Duke Energy Corporation

Subject: Duke Energy Corporation (DEC)
McGuire Nuclear Station, Units 1 and 2
Docket Nos. 50-369 and 50-370
Proposed Amendment to Technical Specification (TS)
3.3.2 - Engineered Safety Feature Actuation System
Instrumentation

Attachment 1

Proposed Changes To The Technical Specifications and Bases Pages

Table 3.3.2-1 (page 4 of 6)
Engineered Safety Feature Actuation System Instrumentation

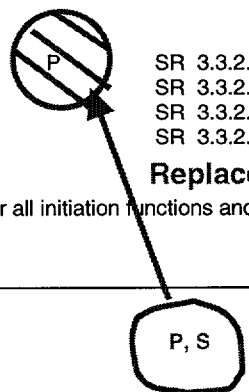
ADD

7. Automatic Switchover to Containment Sump						
a. Refueling Water Storage Tank (RWST) Level - Low	1,2,3	3		SR 3.3.2.1 SR 3.3.2.3 SR 3.3.2.8 SR 3.3.2.9	≥ 175.85 inches	≥ 180 inches
Coincident with Safety Injection	Refer to Function 1 (Safety Injection) for all initiation functions and requirements.

7. Automatic Switchover to Containment Sump						
a. Refueling Water Storage Tank (RWST) Level - Low	1,2,3	3	P,S	SR 3.3.2.1 SR 3.3.2.3 SR 3.3.2.8 SR 3.3.2.9	≥ 175.85 inches	≥ 180 inches
Coincident with Safety Injection	Refer to Function 1 (Safety Injection) for all initiation functions and requirements.
